2017 Ford Mustang V8-5.0L

TECHNICAL SERVICE BULLETIN

19-2273

Inoperative Park Aid Camera, Luggage Compartment Lamp, Luggage Compartment Lid Release And/Or Poor Satellite Radio Reception

Figure 1

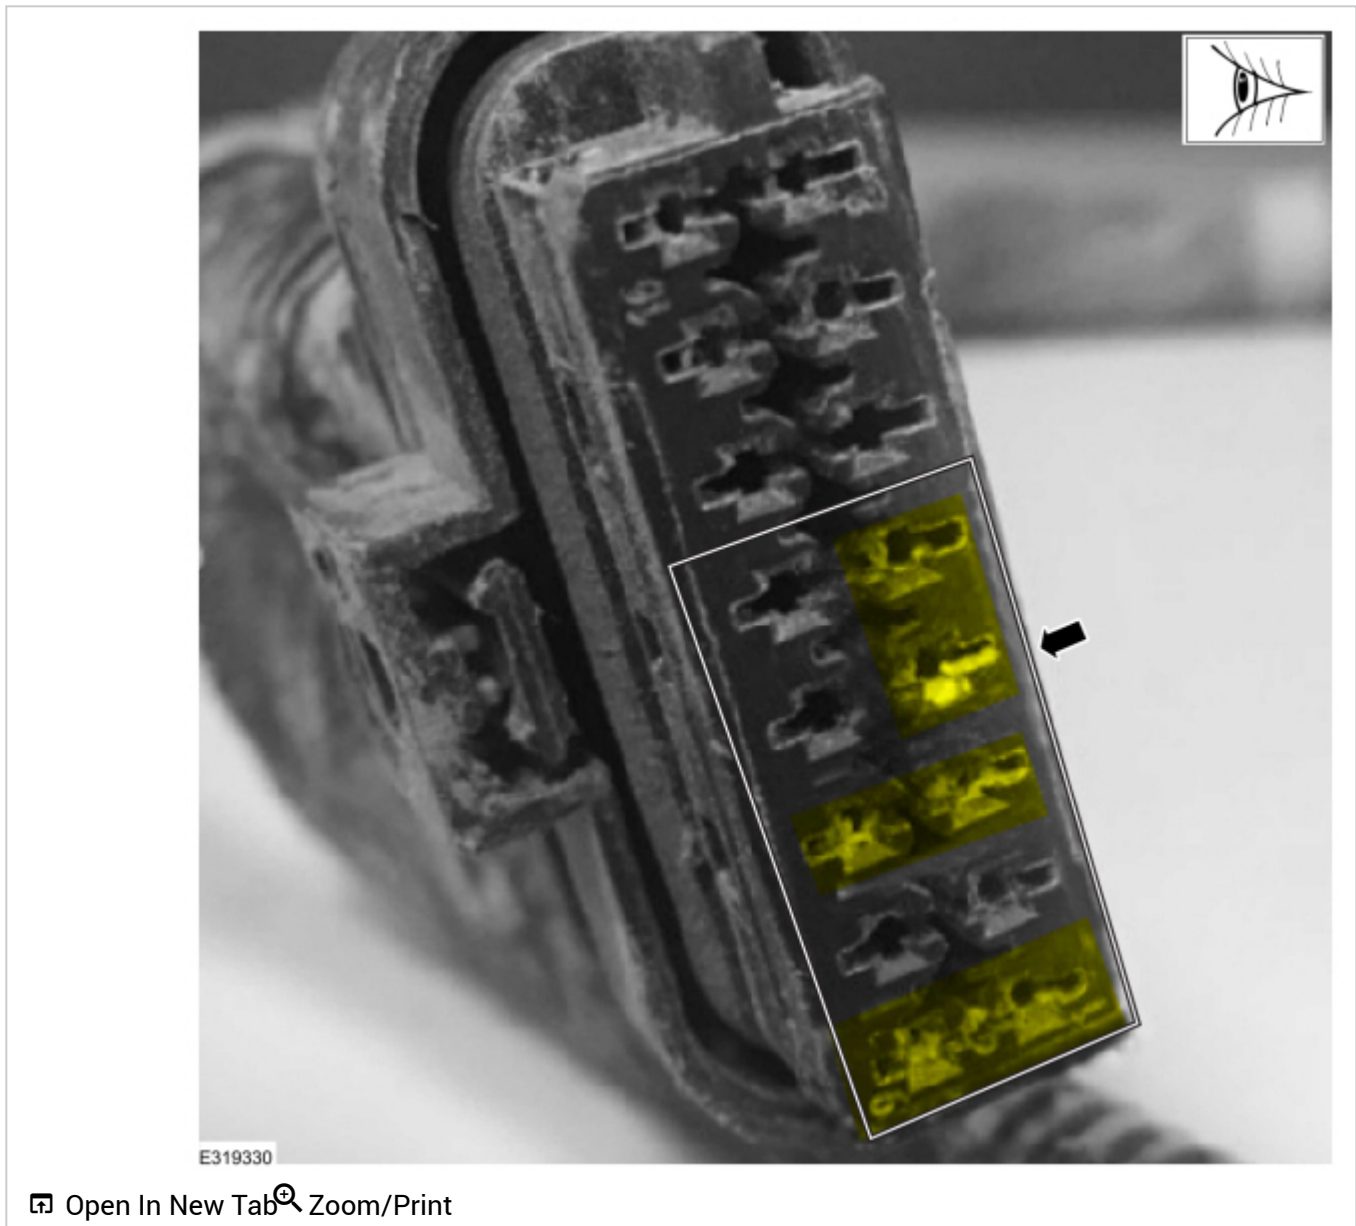
1. Cut out the damaged section of the harness. Make the cut at the location of the harness noted. (Figure 1)

2. Splice in the new section of harness, matching wire colors on the existing vehicle harness and the replacement section of harness as necessary. Follow the recommended wiring splice procedures in Section 5 of the Wiring Diagram. Stagger the location of each of the wire splices along the harness to minimize the overall size of the repair.
3. Wrap the spliced area in Coroplast Electrical Wire Harness Tape or equivalent.
4. Secure the replacement section of harness into the same body holes as the original section of harness was using the clips attached to the replacement section of harness.
5. If DTCs were previously present, connect the appropriate Ford scan tool or equivalent to the DLC and clear all DTCs.

Figure 2

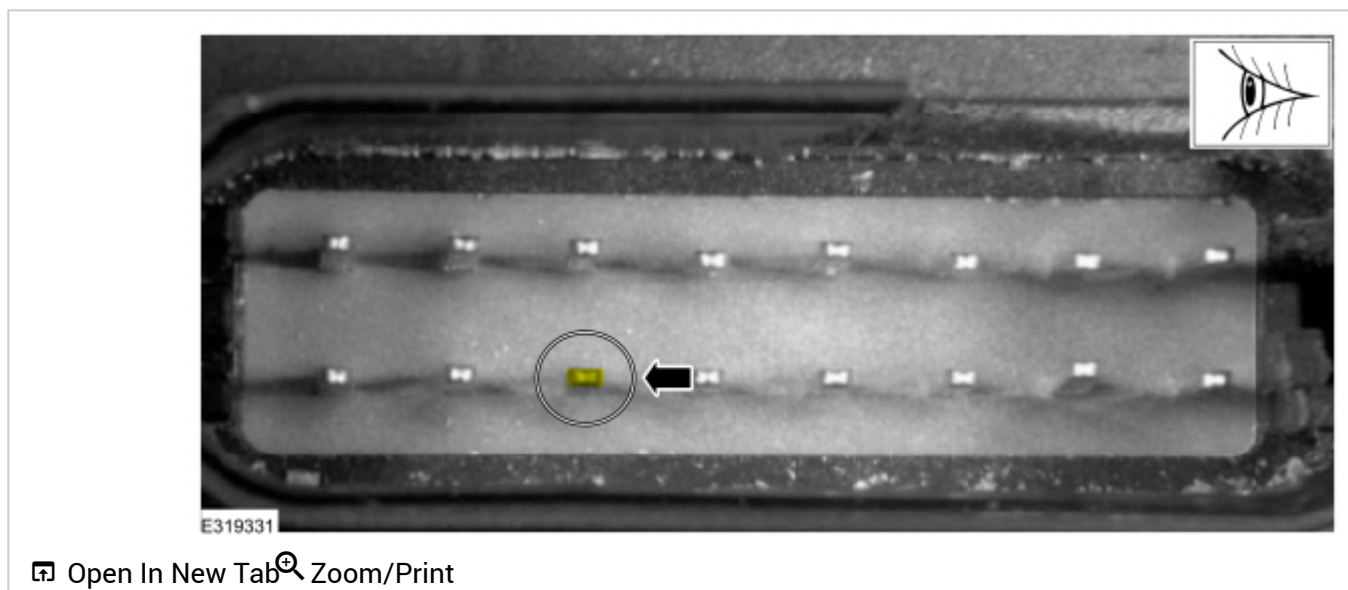
1. Cut out the damaged section of the harness. Make the cut at the location of the harness noted. (Figure 2)

2. Splice in the new section of harness, matching wire colors on the existing vehicle harness and the replacement section of harness as necessary. Follow the recommended wiring splice procedures in Section 5 of the Wiring Diagram. Stagger the location of each of the wire splices along the harness to minimize the overall size of the repair.

NOTE: While it is necessary to cut and remove a section of the old satellite radio antenna cable along with the rest of the harness, do not splice the satellite radio antenna cable where the harness is cut. The satellite radio antenna cable provided with the new harness is long enough to overlay the entire length of the old cable.

3. Remove the existing ground on this section of the harness from the body of the vehicle. Reinstall the ground on the new section of harness to the body of the vehicle.
4. Overlay the satellite radio antenna cable included with the new section of harness. Refer to WSM, Section 415-00B, Satellite Radio Antenna, Removal and Installation.
5. Wrap the spliced area in Coroplast Electrical Wire Harness Tape or equivalent.
6. Secure the replacement section of harness into the same body holes as the original section of harness using the clips attached to the replacement section of harness.
7. If DTCs were previously present, clear all DTCs with the appropriate Ford diagnostic scan tool or equivalent.
